Product Change Notice (PCN)

PCN Number: PCN-0374226R-01

- CPE 1785

❖ Appearance

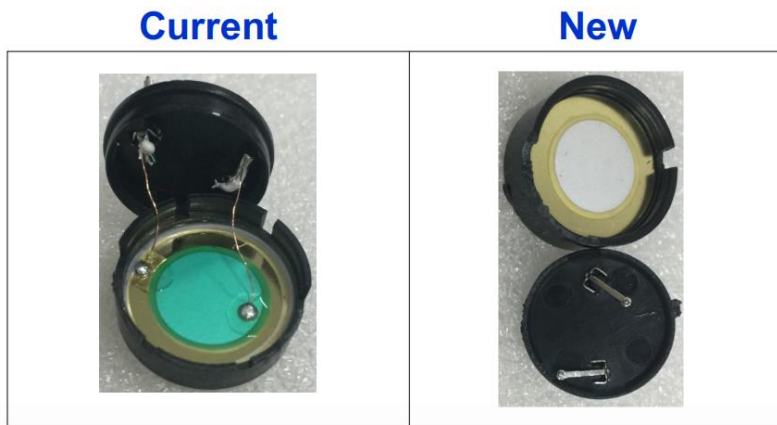
- Case markings Change from NORYL case to PBT
- Bottom notches going from 6 to 2

❖ Inside structure

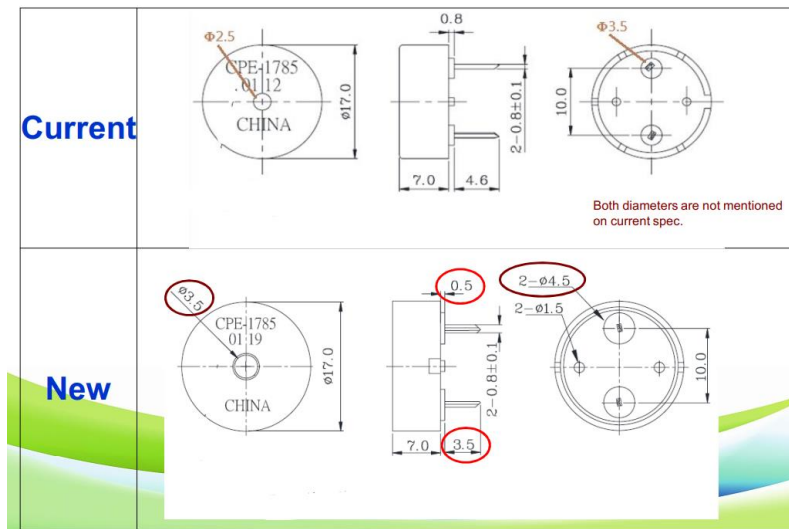
- Change from solder mask on inside to spring contact

❖ Pin length from 4.6mm to 3.5mm
